Yarralumla Residents Association Submission DA 202443505

Site Location & Constraints - Section 56 Block 22 Yarralumla 16 Bentham Street

DA 202443505-Section 56 Block 22 Yarralumla

Figure 1 – Location of proposed Development within Yarralumla and Zoning

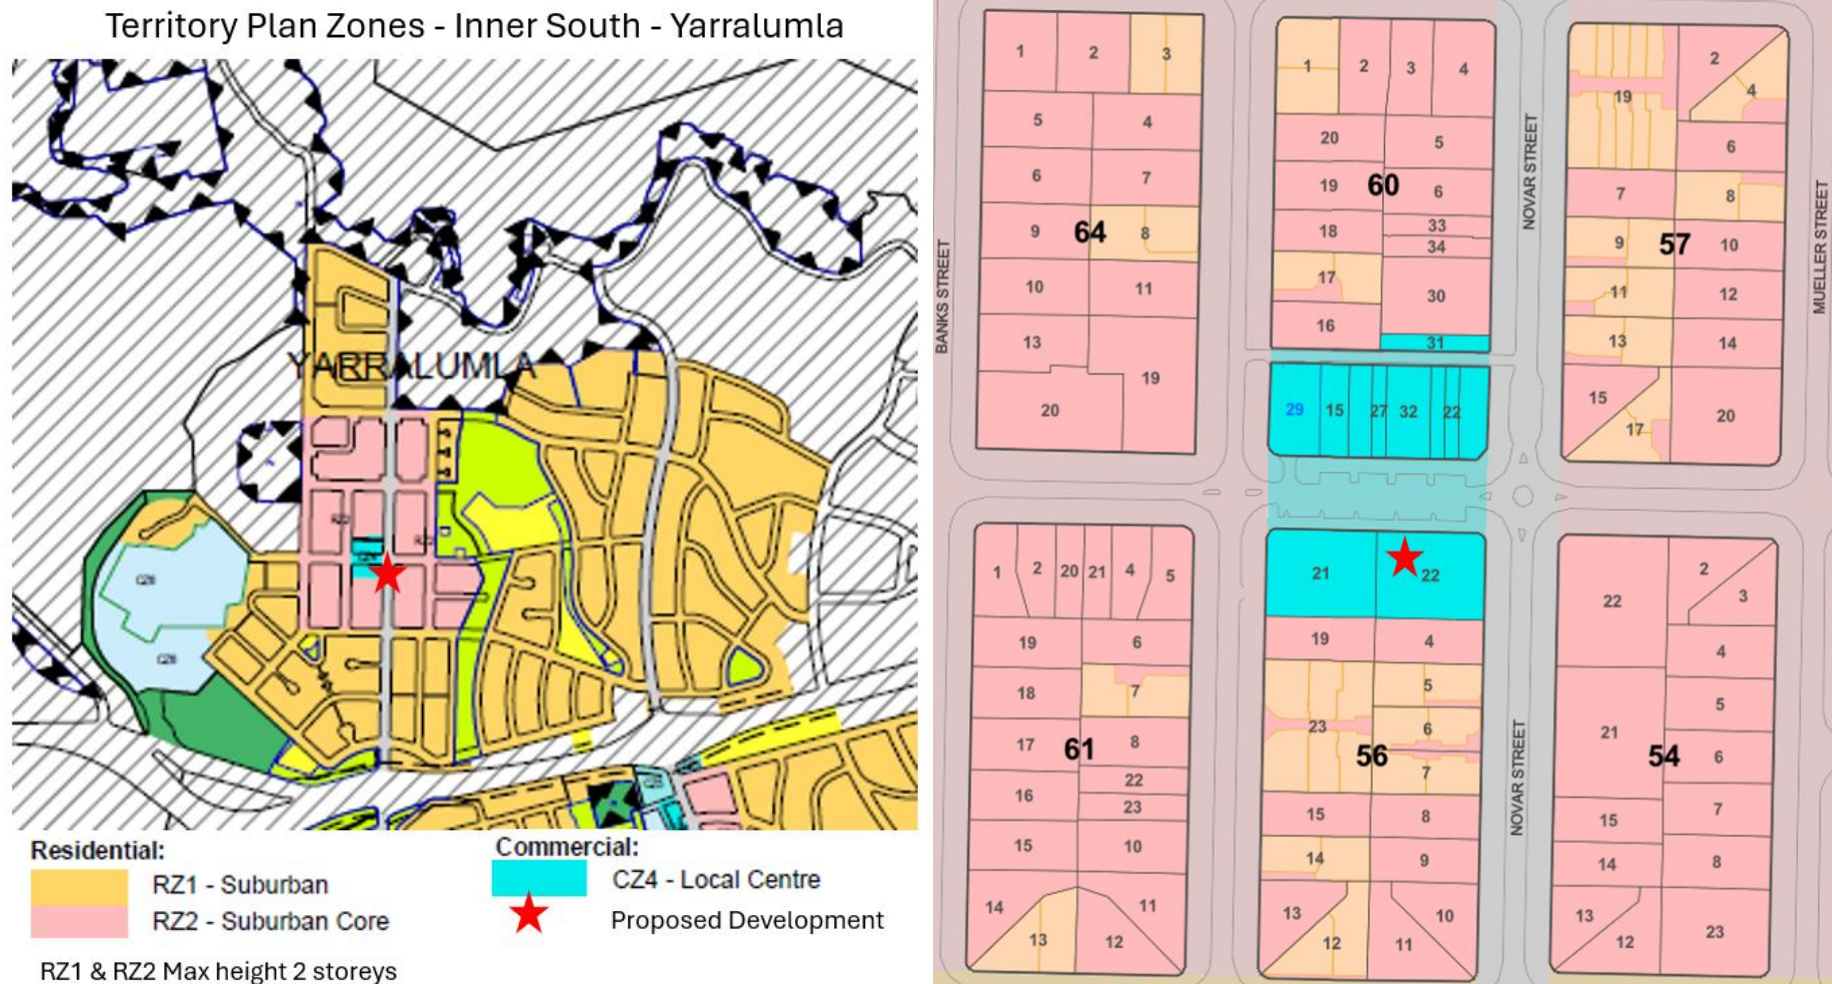
The scale of the proposed Development of 5 storeys, in effect 6 storeys owing to Lift Towers and Mechanical Venting on the roof, is not appropriate to the site or zone CZ4. The Commercial Zones Policy for CZ4 Local Centre Zone has a maximum building height of 2 storeys ([Figure 1](#)).

The scale of the proposed Development of 5 storeys is not appropriate to the site or zone - CZ4 Local Centre which sets a maximum building height of 2 storeys ([Figure 1](#)).

Figure 2- PLAN shows 14 of 16 Garbage Bins for 14 Multi Use Residential Development Units collected on nature strip of 39 Novar Street a Single Storey Residence taking up more two thirds of the area

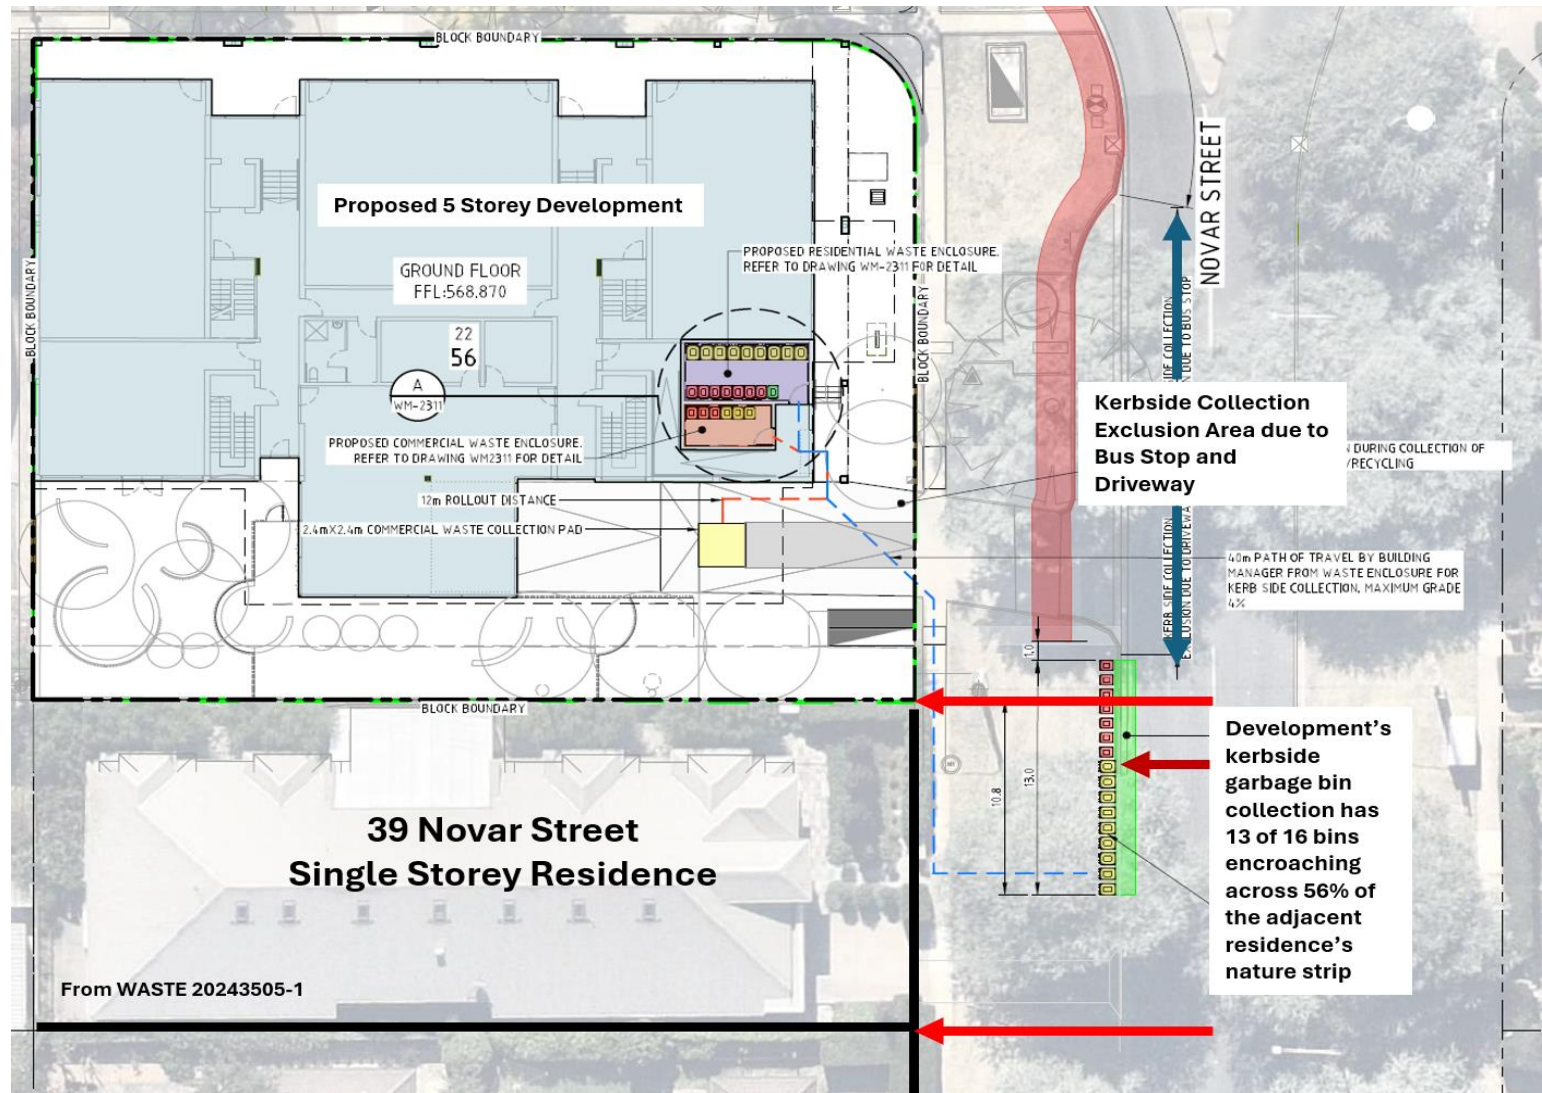
Kerbside waste collection of 14 of the multi residential unit bins is NOT located on the Site's kerbside BUT on the adjacent property at 39 Novar Street impacting on the property's amenity and responsibility to maintain the nature strip ([Figure 2](#) and [Figure 3](#)).

If the garbage compound is not enlarged then the only place for the Hoppers to be stored and emptied is on the neighbour's nature strip alongside the site's residential units garbage bins ([Figure 2](#)).

The proposed kerbside waste collection is non-compliant with the *Development Control Code for Best Practice Waste Management in the ACT 2019* and has an unacceptable impact on the residence at 39 Novar Street and its nature strip frontage ([Figure 2](#)). Noting also that the owners of this property have the responsibility for the maintenance of their nature strip.

Figure 5 - PLAN - Commercial Garbage Trucks turn in Bus Stop Bay and block Basement carpark access

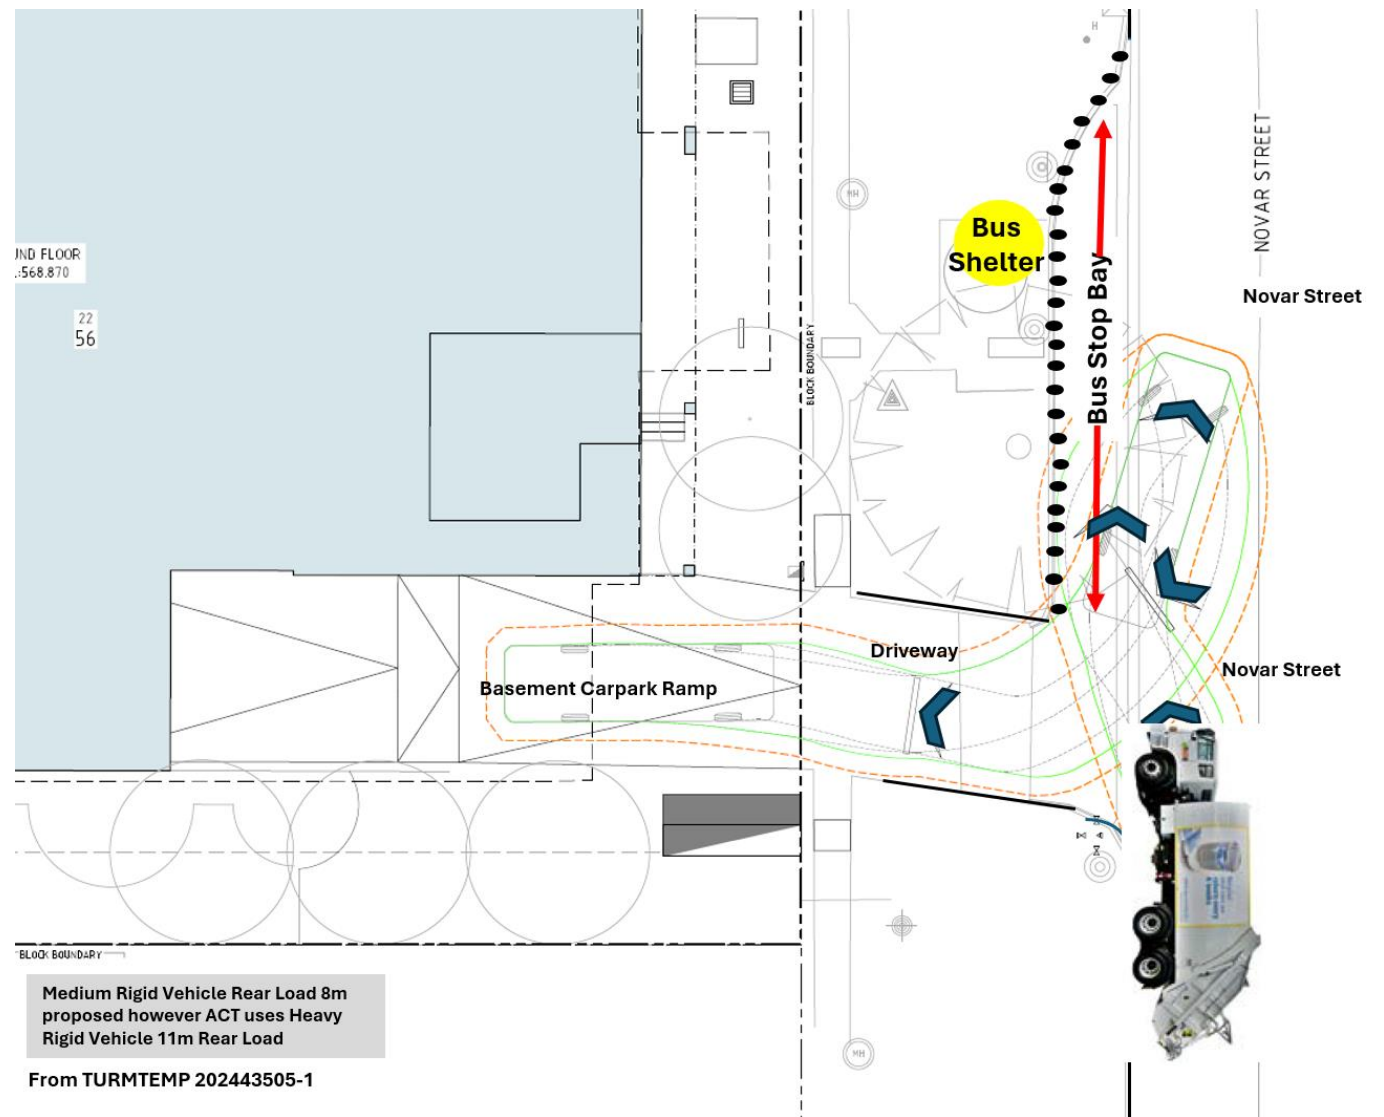
This underestimate of waste generation has consequences ([Figure 5](#), [Figure 6](#) and [Figure 7](#)):

- many more bins upscaled to Hoppers and emptied on a daily basis;
- a much larger commercial waste storage compound;
- manhandling of Hoppers to a flat collection point;
- a front loading, forward entry, 12.5 metre Garbage Truck that will reverse out of the site into the Bus Stop Bay next to the roundabout on Novar Street.

For the residential waste from the Development's 14 Units, the proposed designated kerbside collection point is not on the kerb frontage for the development as this is an exclusion zone because of the Bus Stop Bay ([Figure 5](#)). Instead the Development proposes to use most of the nature strip of the adjoining property 39 Novar Street for kerbside collection of 14 of the 16 garbage bins ([Figure 2](#)). This does not meet the requirements R2.4 of the *Development Control Code for Best Practice Waste Management in the ACT 2019*, which is "the location of the designated collection point, dimensions of the available kerb frontage for the development, clearances to street trees and other obstructions and the indicative MGB presentation layout to ensure sufficient space".

From SEDIMENT-202443505-01

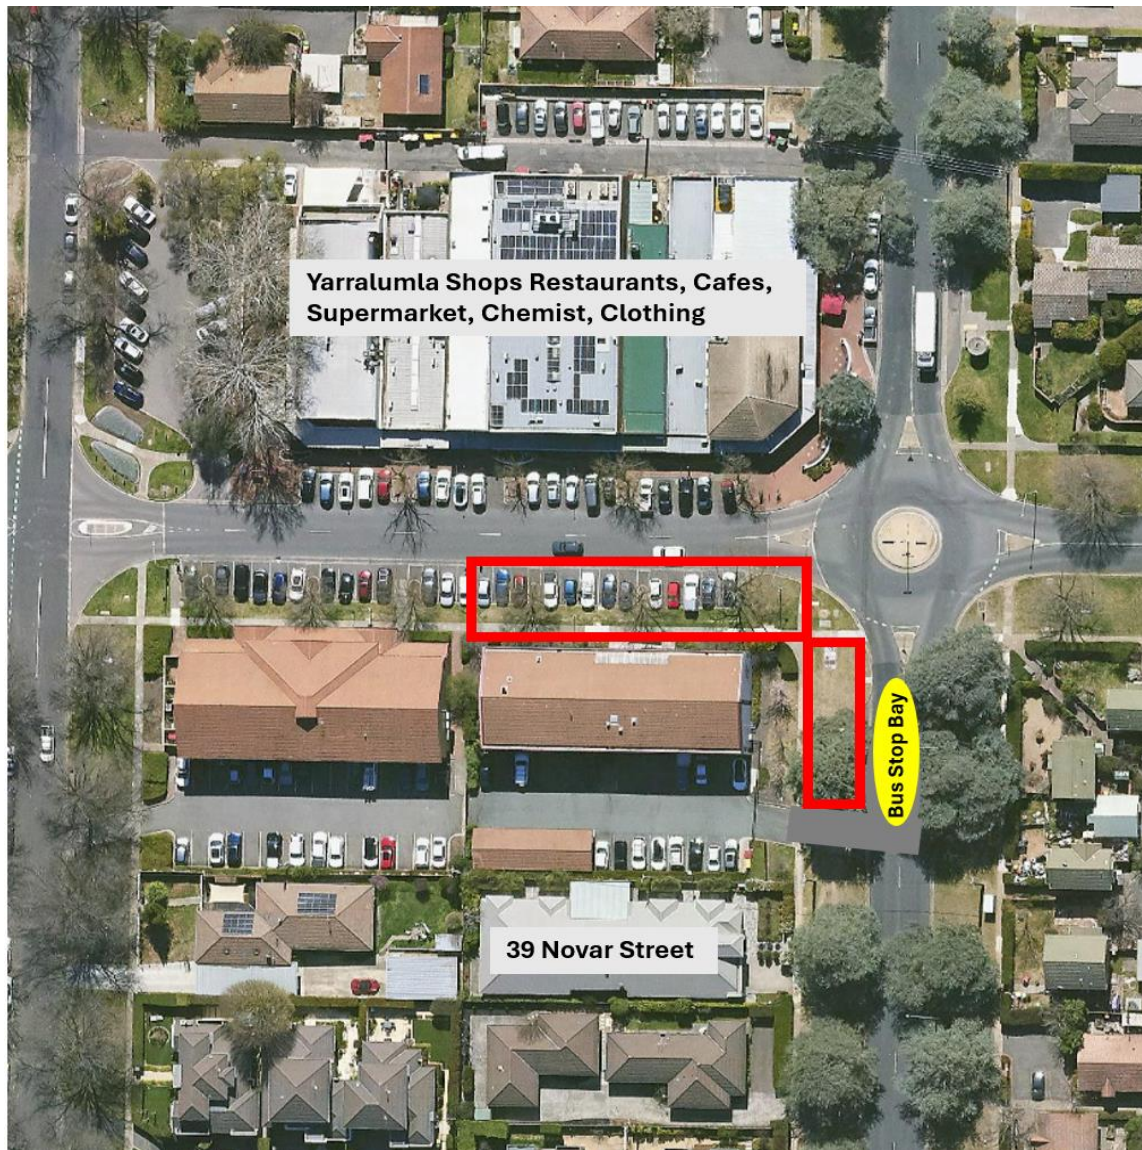
It is not possible for demolition and construction activities and materials to be managed on site. It is not possible, as proposed, to retain the existing carpark area and use it for access to stockpile materials, site sheds and construction waste, whilst at the same time excavating the area for basement carparks ([Figure 8](#)).

The Plan SEDIMENT- 202443505-1 identifies that the existing carpark area is to be retained during construction, and the construction materials stockpile, construction waste bins and site sheds and amenities are located against the boundary of the 39 Novar Street residence with their associated dust noise and constant activity ([Figure 8](#)).

The proposed Development requires not only the demolition of the two storey office building and carpark but also the excavation of 85% of the site for the construction of the two levels of basement carparks and access ramps. Thus it is not possible to retain the existing carpark area and use for access to stockpile materials, site sheds and construction waste whilst at the same time excavating it for basement carparks ([Figure 8](#)).

Existing Carpark area to be retained during construction
Note this area must be excavated for basement carpark

Site facilities not accessible during excavation
